CITY OF OREGON CITY PLANNING COMMISSION AGENDA

Staff Report

GLUA-23-00006 (General Land Use Application), SP-23-00016 (Site Plan and Design Review), VAR-23-00001 (Variance), and PARK-23-00001 (Parking Adjustment) for new construction located at 1689 Molalla Avenue.

FILE NUMBER: GLUA-23-00006:
SP-23-00016 – Site Plan and Design Review
VAR-23-00001 – Variance
PARK-23-00001 – Parking Adjustment

Figure 4: Proposed Site Plan

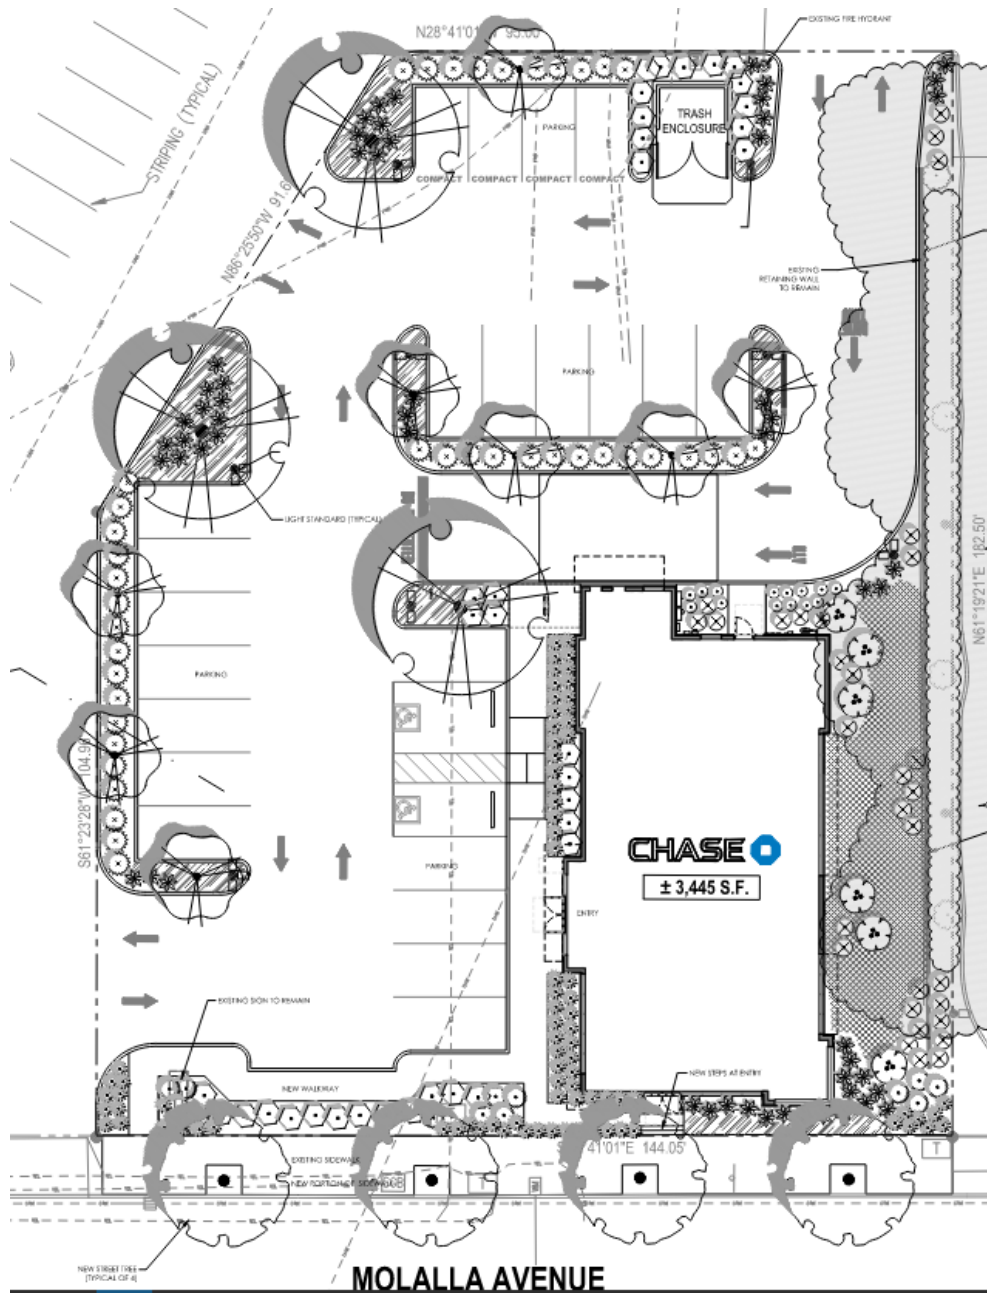
16. The applicant shall provide a roof plan that demonstrates compliance with screening requirements for roof-top mechanical equipment. (P)
17. The applicant shall submit a revised site plan identifying at least one additional element from the amenity list in OCMC Section 17.62.055.D to be located within thirty feet of street-facing property line. (P)

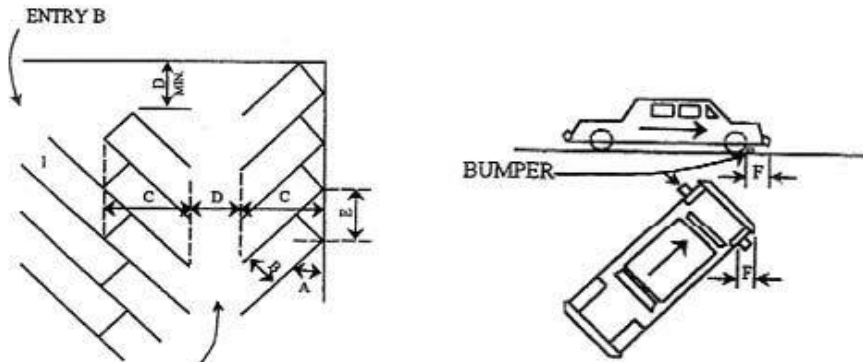
Finding: Complies as proposed. The applicant has proposed twenty-four (24) 90-degree parking stalls. The proposed stalls include eighteen (18) standard stalls, four (4) compact stalls, and two (2) ADA stalls. The stalls are in compliance with the stall width and length requirements. The widths of the aisles generally comply with the requirement of twenty-four (24) feet.

Proposed site plan.

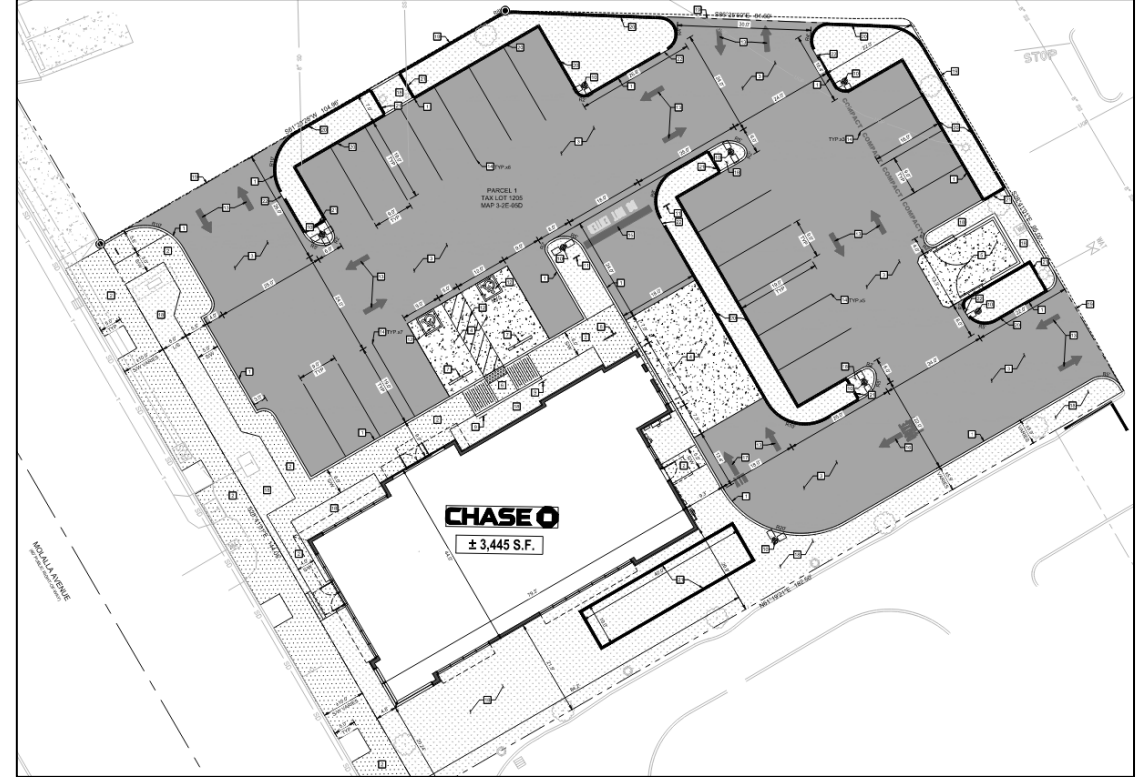
- The Oregon City Municipal Code includes parking maximums which would allow for a maximum of 16 parking stalls for the subject property.
- The site current exceeds the maximum allowed by the code, with a 17-stall parking lot.
- The applicant has identified that the existing parking lot would not meet the parking needed by staff and clients of the bank. The applicant has requested approval of a Planning Commission Parking Adjustment in order to construct a 24-stall parking lot.
